1972 Corvette: Service News: Front Fender Skirt Availability

Subject: Corvette Service Fender Skirt

Model and Year: 1972 Corvette

Date: September 1974, Volume 46, Issue #9

Fig. 2—Corvette Fender Rework

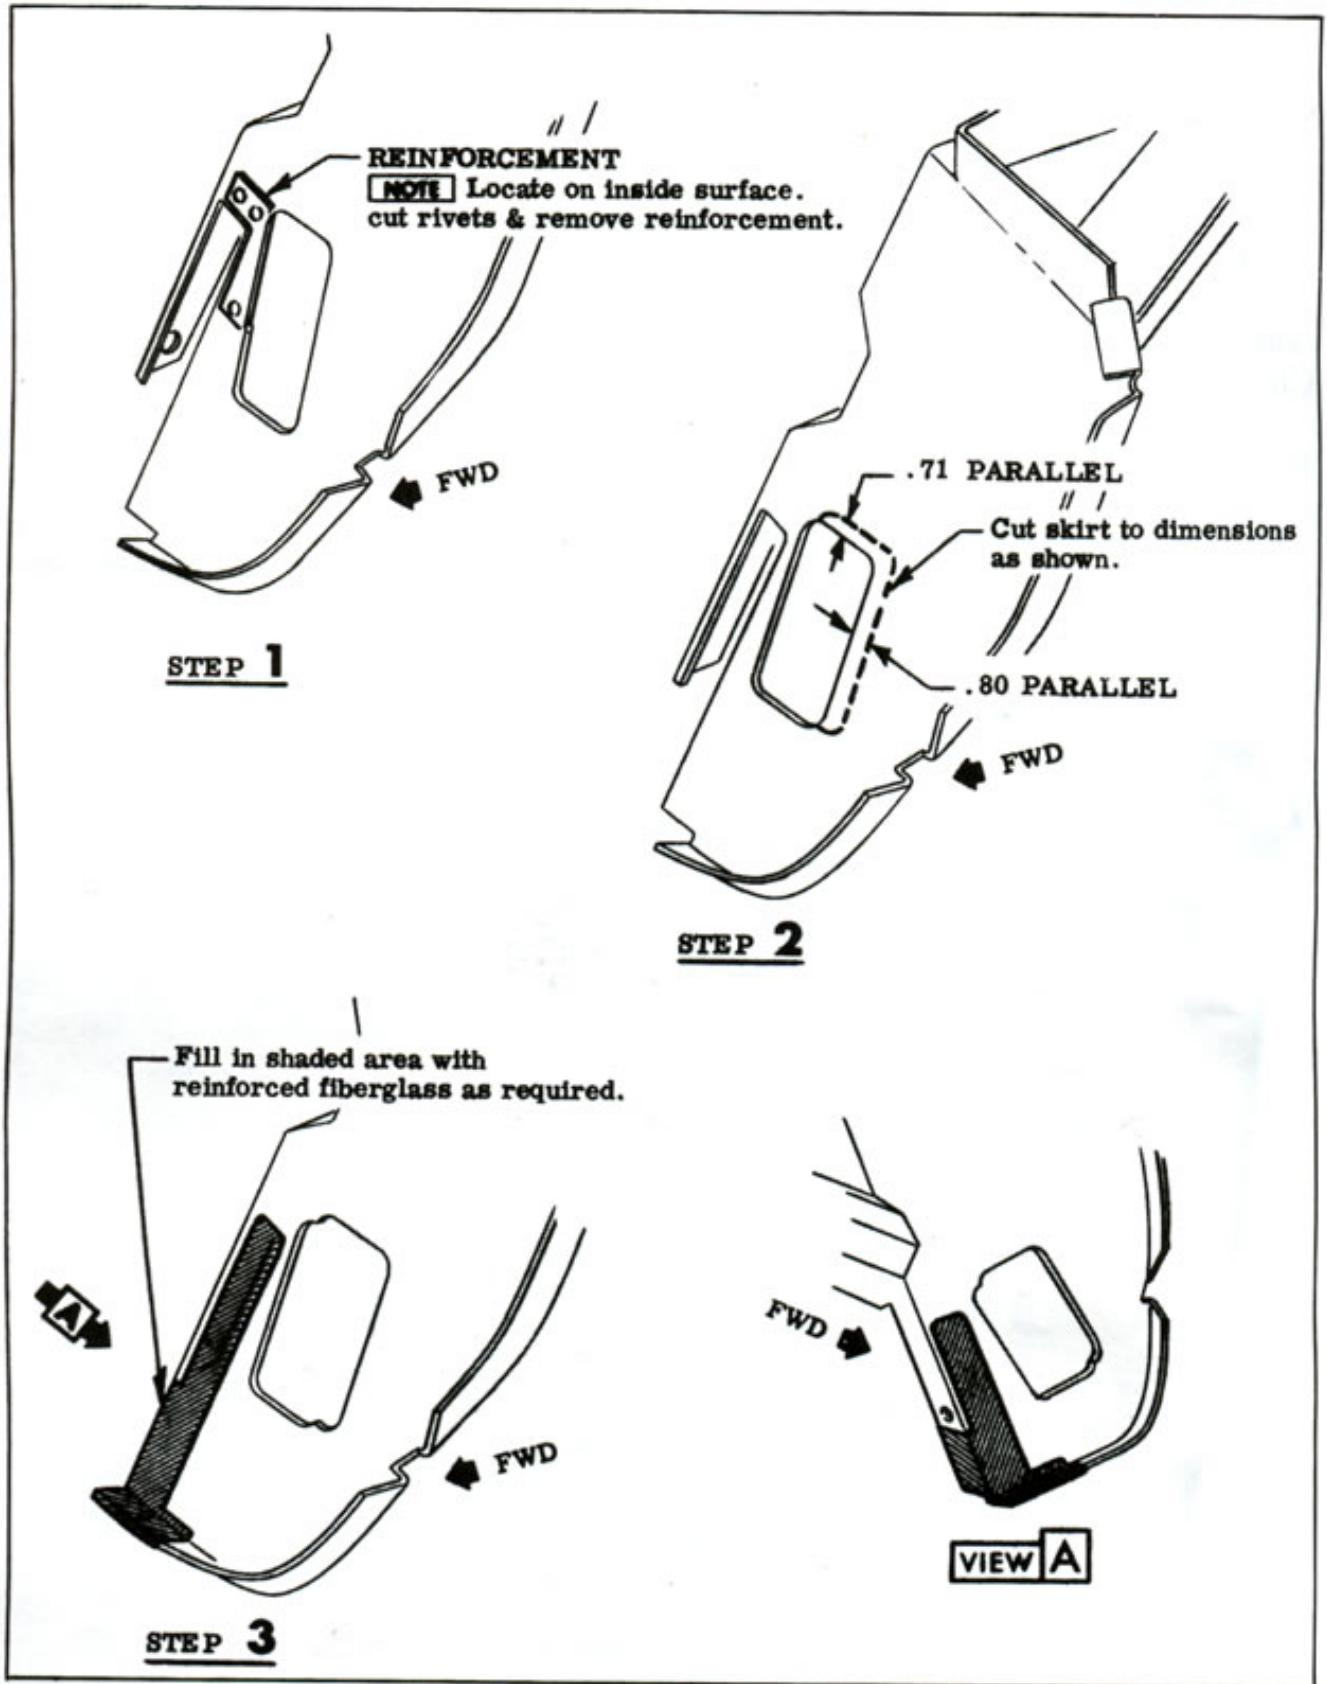
The 1972 Corvette Front Fender Skirts 6263509 L.H. and 3953054 R.H. are being cancelled and will be serviced by the 1973 Fender Skirts 331857 L.H. and 331858 R.H. This is being done because the tools have been reworked to make the 1973 skirt.

When using the 1973 skirts in place of the 1972 skirts, it will be necessary to remove and the steel reinforcement part number 334747-8 and add a material patch to provide a mounting surface for the radiator lower grille. See Fig. 2 for additional information.
